BMW Motorrad USA

Service Information Bulletin

****Notice of Recall 10V-496****

Subject: Threaded fasteners, front brake disc F 650 GS (K72)
This Service Information Bulletin supersedes the two previous ones. Changes / Additions are in Bold blue text.

Figure 1: Threaded fasteners, front brake disc, F 650 GS

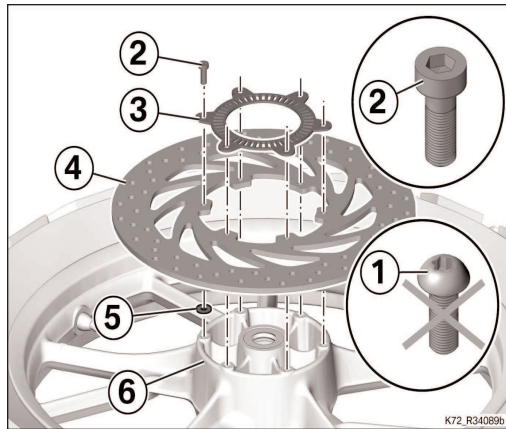
Details: Within the framework of quality monitoring, it has been determined that the torque of the M6x18 bolts securing the front brake disc of F 650 GS (K72) models is insufficient. **Ongoing trials showed that under conditions of extreme load, individual screws can work loose. This is due to the settling of the anti-squeal washers installed between the brake disc and wheel. Contrary to the 1st supplement (April 2010) to this Service Information bulletin, the occurrence of safety-critical riding condition can be excluded ONLY when the front brake disc is installed WITHOUT anti-squeal washers and with the long screws 36 31 7 671 267, M6 x 20 tightened to 11 Nm (construction status 3). As a result, this recall has to be extended to include motorcycles that were completed previously with the longer screws 36 31 7 671 267, M6 X 20 and with anti-squeal washers installed (construction status 2).**

Aftersales Solution: Make sure you have read and complied with the following before handing over the motorcycles to the customers. On all the motorcycles affected by this problem, the six old shorter M6x18 star-head screws (1) in figure 1 on the following page, securing the brake disc to the front wheel must be removed and replaced by the new longer M6x20 socket-head screw (2) and the six anti-squeal washers (5) installed between the brake disc (4) and wheel hub (6) **MUST BE REMOVED. If longer M6x20 socket head screws are removed new ones are to be installed.**

The tightening torque for the new screws is 11 Nm!

Figure 2: New, thinner spacing bushing with circumferential groove (left), old spacing bushing (right)

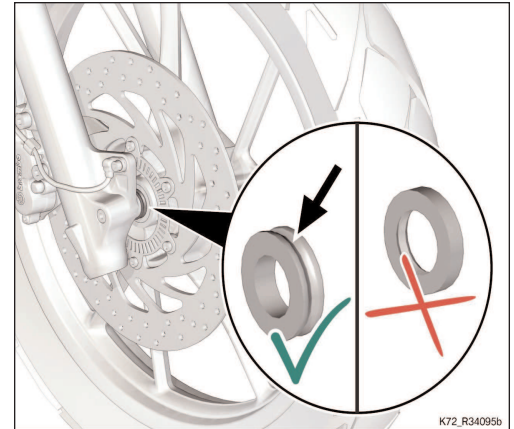
In addition the spacing bushing in figure 2 on following page must be removed and replaced by a thinner spacing bushing with circumferential groove, in order to ensure that the brake disc is correctly positioned relative to the brake caliper and the wheel-speed sensor.
